TRANS/WP.29/GRSG/57  
28 July 2000

REPORT OF THE WORKING PARTY ON GENERAL SAFETY PROVISIONS (GRSG)  
ON ITS SEVENTY-EIGHTH SESSION

(10 to 14 April 2000)

Figure 3: determination of the datum points  
(example of a left-hand vehicle)"

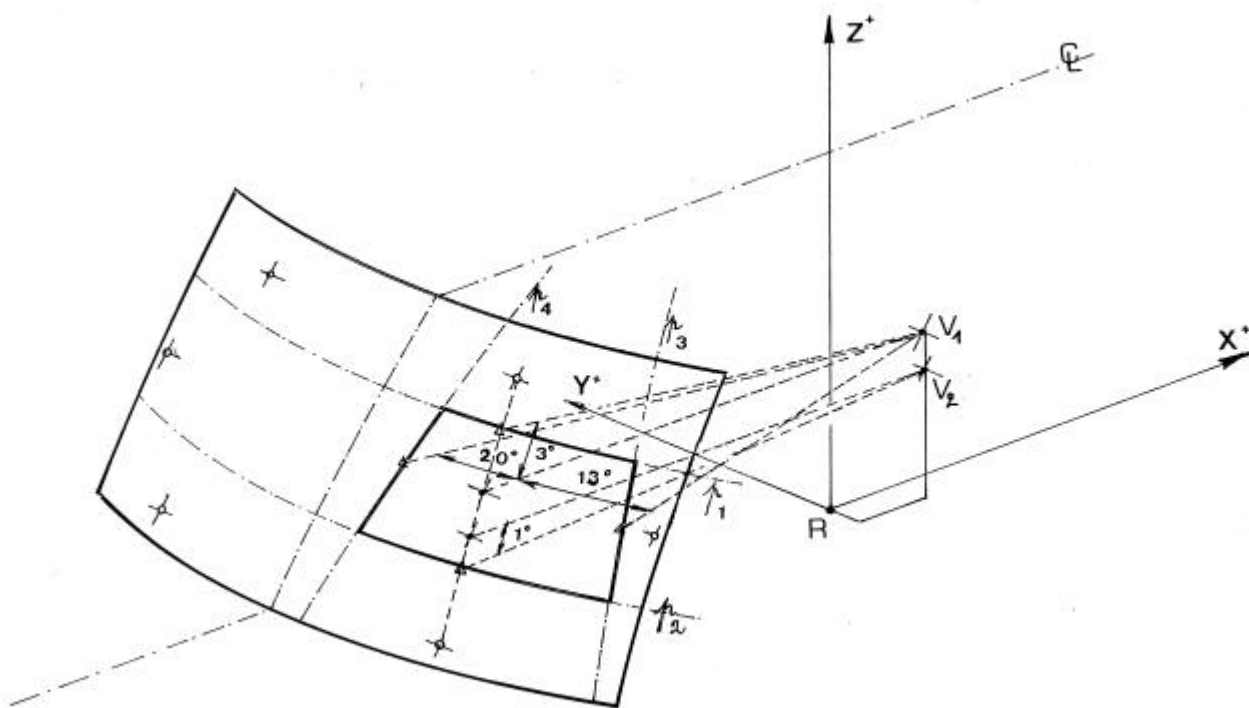
2.5. Definition of the datum points (see figure 3)

The datum points are points situated at the intersection with the outer surface of the windscreen of lines radiating forward from the V points:

2.5.1. upper vertical datum point forward of V1 and  $7^\circ$  above the horizontal (Pr1);

2.5.2. lower vertical datum point forward of V2 and  $5^\circ$  below the horizontal (Pr2);

2.5.3. horizontal datum point forward of V1 and  $17^\circ$  to the left (Pr3);

2.5.4. three additional datum points symmetrical to the points defined under paragraphs 2.5.1. to 2.5.3. in relation to the longitudinal median plane of the vehicle (respectively Pr'1, Pr'2, Pr'3)."

Figure 1: test area "A" (example of a left-hand vehicle)

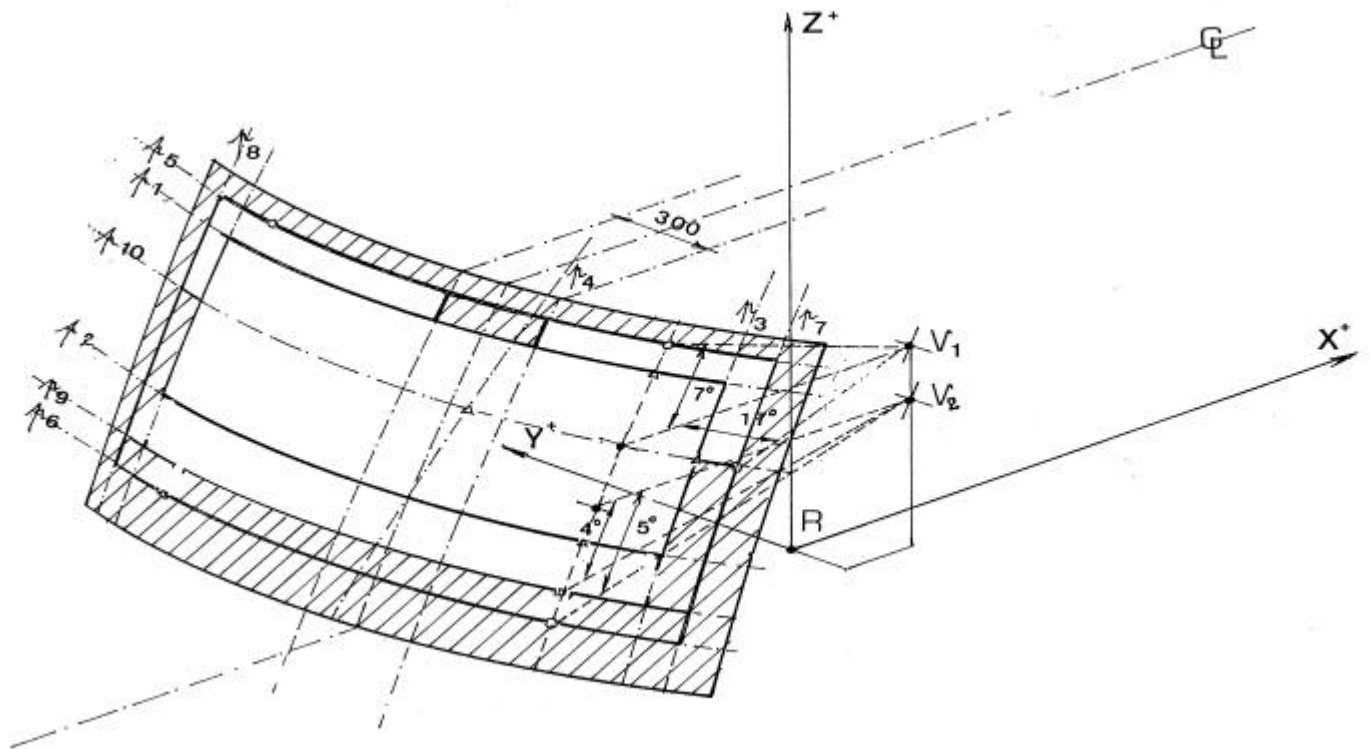
"2.2. "Test area A" is the area of the outer surface of the windscreen bounded by the intersection of the following four planes (see figure 1):

- (a) a plane inclined upwards from the X axis at 3°, passing through V<sub>1</sub>, and parallel to the Y axis (plane 1);
- (b) a plane inclined downwards from the X axis at 1°, passing through V<sub>2</sub>, and parallel to the Y axis (plane 2);
- (c) a vertical plane passing through V<sub>1</sub> and V<sub>2</sub> and inclined at 13° to the left of the X axis in the case of left-hand drive vehicles and to the right of the X axis in the case of right-hand drive vehicles (plane 3);
- (d) a vertical plane passing through V<sub>1</sub> and V<sub>2</sub> and inclined at 20° to the right of the X axis in the case of left-hand drive vehicles and to the left of the X axis in the case of right-hand drive vehicles (plane 4)."

Figure 2a: reduced test area "B" (example of a left-hand vehicle) - upper obscuration area as defined in paragraph 2.4.2.2.

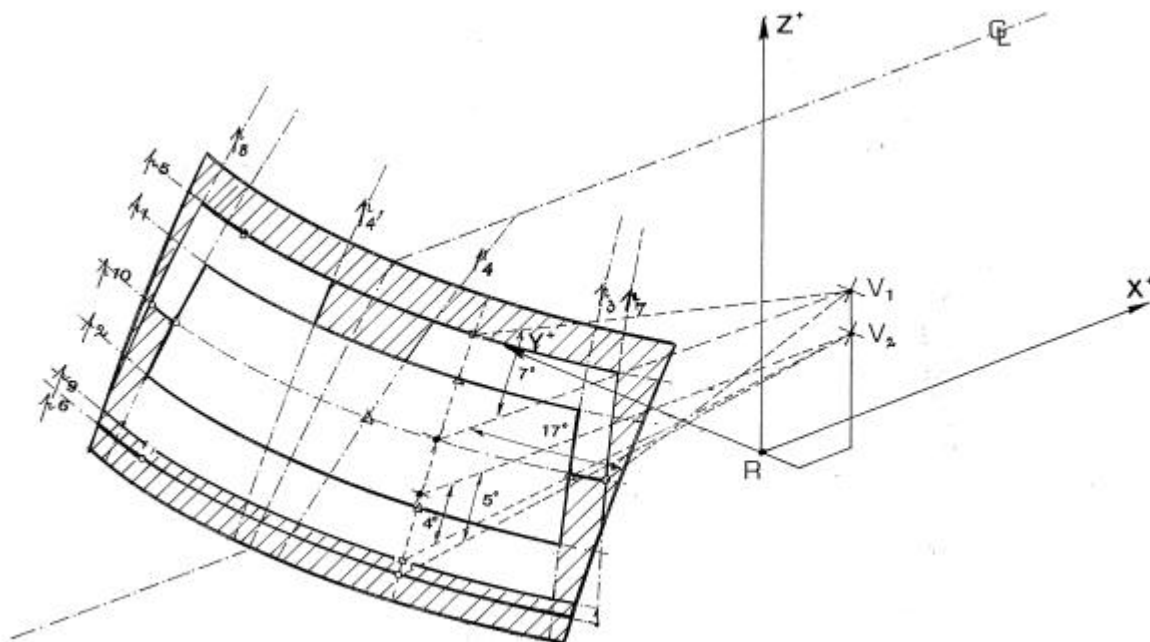
- 2.4.2.2. any opaque obscuration bounded downwards by plane 1, of maximum width 150 mm 2/, provided it is inscribed in an area of width 300 mm centred on the longitudinal median plane of the vehicle;

Figure 2b: reduced test area "B" (example of a left-hand vehicle)  
- upper obscuration area as defined in paragraph 2.4.2.1.

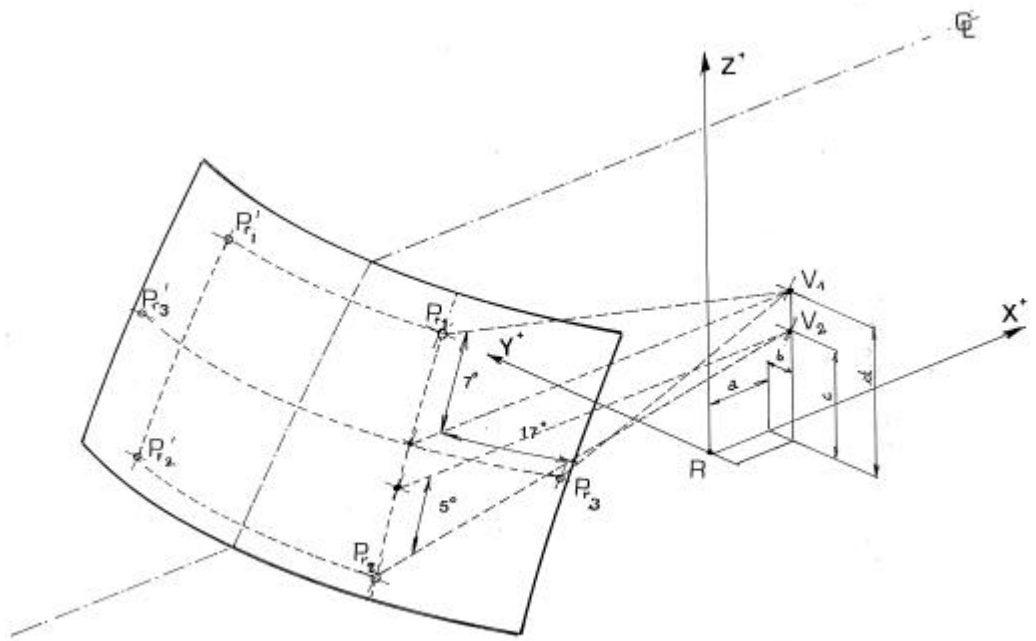
- 2.4.2. at the discretion of the vehicle manufacturer, one of the two following paragraphs may apply:
- 2.4.2.1. any opaque obscuration bounded downwards by plane 1 and laterally by plane 4 and its symmetrical in relation to the longitudinal median plane of the vehicle (plane 4');;
